TELEVISION TECHNICAL BULLETIN

<u>MODELS</u>	56FW53H	66FW53H	66FW54H	76FW53H
	76FW54H	59ESD7H	66ESD7H	28HW53H
	66GF63H	66GF64H	76GF64H

Reference JR29042003-8

Revision 2

Location of D735 (note the use of hot melt glue to prevent the diode from shorting out to the tracking)

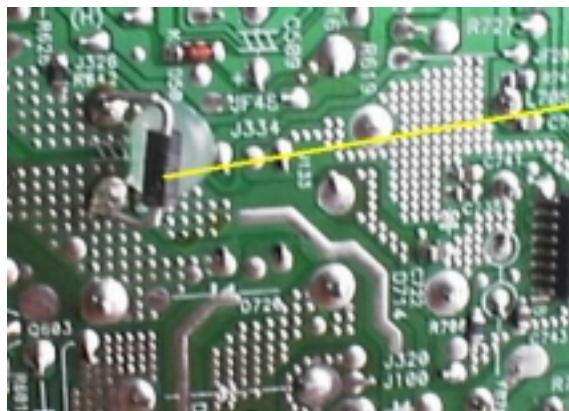
ACTION In most cases, when the HT rises D735 fails and no other components are damaged. Replace D735 and IC705 using the part numbers listed below. (D735 may be soldered under C720)

To alleviate damage to other parts of the circuitry when the HT rises, an avalanche diode was fitted across the main HT smoothing capacitor (C720) from late 1999 production. This device has a rated maximum voltage of 170V, and will go short circuit if this voltage is reached. This diode must be fitted to all chassis (part number RH-EX0875BMZZ).

- When replacing **any** opto coupler ensure that the soldering temperature is **below 250°C**.
- To ensure that excessive HT does not cause further problems, if not previously fitted make sure that an avalanche diode (D735) is fitted across C720 on the print side of the PWB. The cathode of the diode should be connected to the positive side of C720.
- An alternative (4pin) opto coupler may be supplied, read bulletin **CTV2002 05 02** prior to fitting

Location of Audio Stage components (Main PWB)

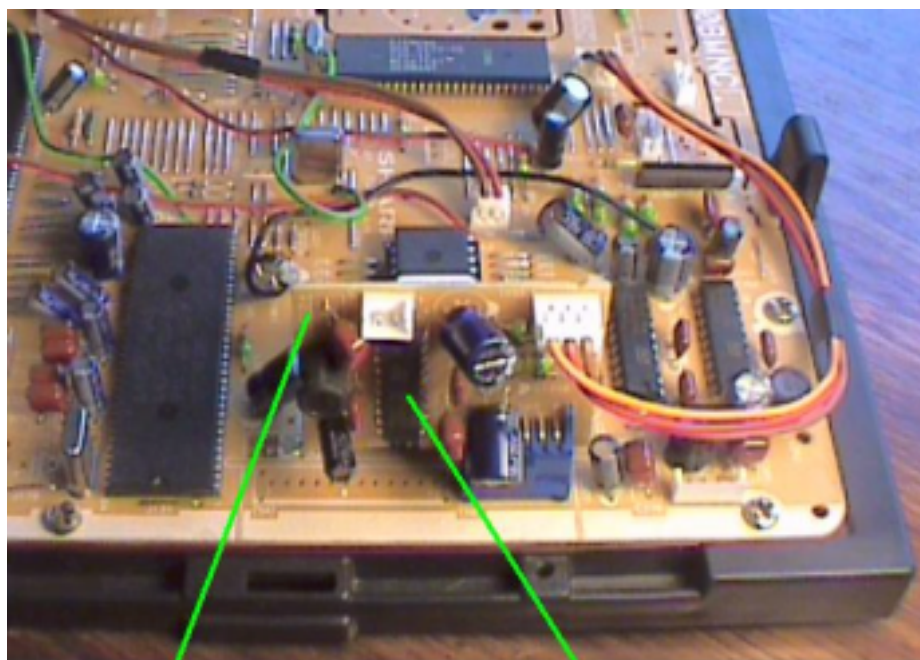
Ref	Function	Part Number	Comment
Q602	Horizontal output transistor	RH-TX0192BMZZ	Leaky or short circuit
IC301/2	Audio output IC's	VHITDA7480/-1	Short circuit. Also check supply feed chokes
IC1801	CDA IC on CRT base PWB	Refer to service manual	Short circuit. Check pin 5 to ground (<500Ω)
C720	HT reservoir capacitor	RC-EZ0258CEZZ	Physically damaged
IC1301	Centre channel amplifier	VHITDA7480/-1	Short circuit. Located on centre speaker PWB
Q5407	Scan velocity modulator transistor	VS2SA1837//1	CRT PWB – short or open circuit
Q5408	Scan velocity modulator transistor	VS2SC4793//1	CRT PWB – short or open circuit
L315/316	IC302 feed chokes	VP-CF3R3K0000	Open circuit
L350/351	IC301 feed chokes	VP-CF3R3K0000	Open circuit

Location of Components on the CRT PWB - 66cm and 76cm versions only (the PWB fitted to the 56FW53H does not have Q5407/Q5408 fitted and is physically smaller than this example)

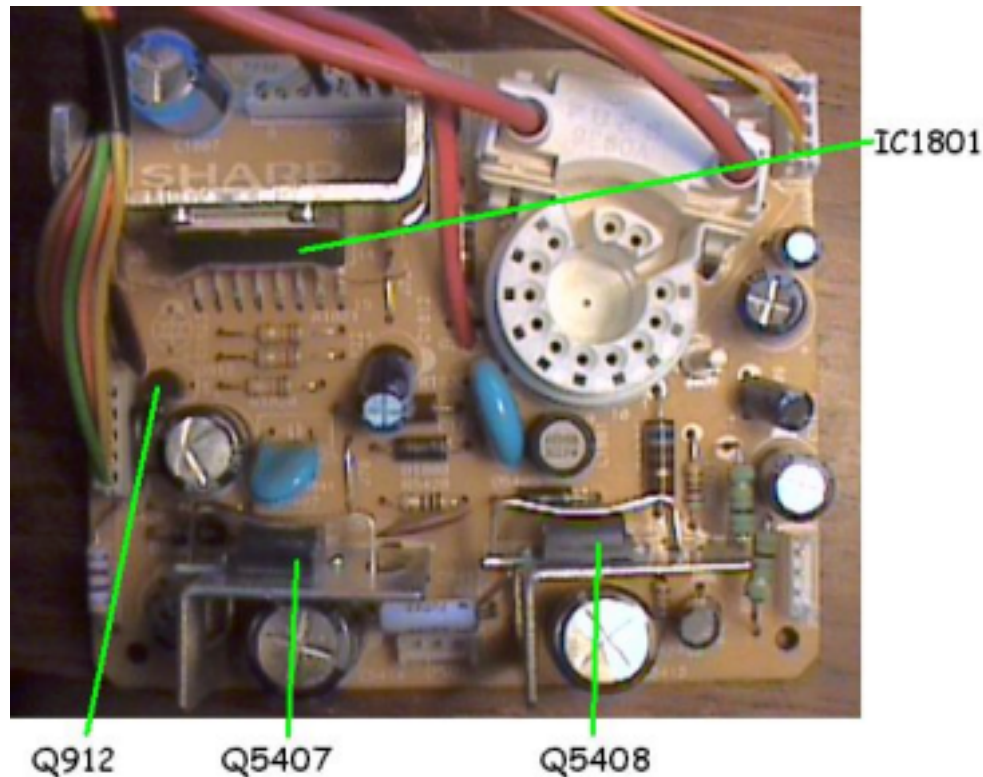
If the set is operated for prolonged periods without the avalanche diode fitted, then damage will occur to other parts of the circuit. The CRT PWB suffers normally all the electrolytic capacitors have to be replaced if this is the case. The moral is, **DO NOT** run the set when high HT is present.
